UNITED STATES  
DEPARTMENT OF THE INTERIOR  
BUREAU OF LAND MANAGEMENTFORM APPROVED  
OMB NO. 1004-0137  
Expires: January 31, 2018**SUNDRY NOTICES AND REPORTS ON WELLS**  
**Do not use this form for proposals to drill or to re-enter an abandoned well. Use form 3160-3 (APD) for such proposals.**5. Lease Serial No.  
NMNMO405444

**SUBMIT IN TRIPLICATE - Other instructions on page 2**8. Well Name and No.  
TODD 230 FED 19. API Well No.  
30-015-20796-00-D110. Field and Pool or Exploratory Area  
INGLE WELLS-DELAWARE11. County or Parish, State  
EDDY COUNTY, NM1. Type of Well  
☒ Oil Well ☐ Gas Well ☐ Other2. Name of Operator  
DEVON ENERGY PRODUCTION COMPANY  
Contact: ARMON RADFAR  
Email: ARMON.RADFAR@DVN.COM3a. Address  
333 WEST SHERIDAN AVENUE  
OKLAHOMA CITY, OK 731023b. Phone No. (include area code)  
Ph: 405-552-50144. Location of Well (Footage, Sec., T., R., M., or Survey Description)  
Sec 23 T23S R31E SWSE 660FSL 1650FEL

\*\* BLM REVISED \*\* BLM REVISED \*\* BLM REVISED \*\* BLM REVISED \*\* BLM REVISED \*\*

PROPOSED WELLBORE

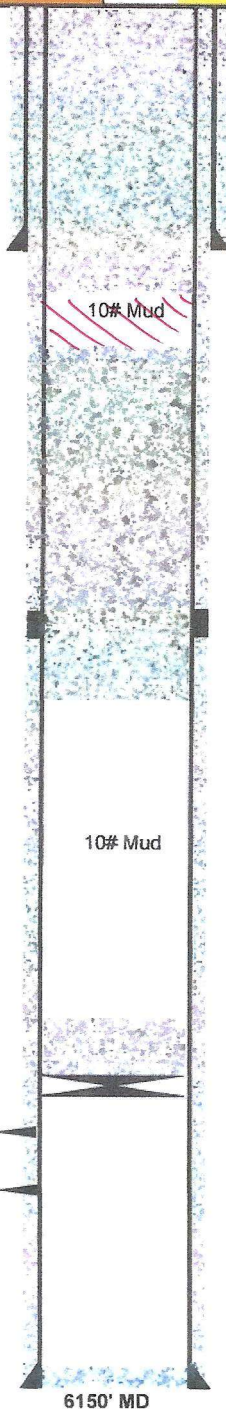
- Spot ~~340~~ sx CI C from 4425'-~~1035~~' WOC & tag. (T. Delaware @ 4372'; DV tool @ 4290'; B. Salt @ 4140'; T. Salt @ 1085; R-111P solid plug)

450 sx

surface

verify @ surface

1. Set CIBP @ 5970'. Tag. Circ 10# salt gel. Leak test CIBP
2. Spot 25 sx CI C from 5970'-5720'. (Perfs @ 6017')
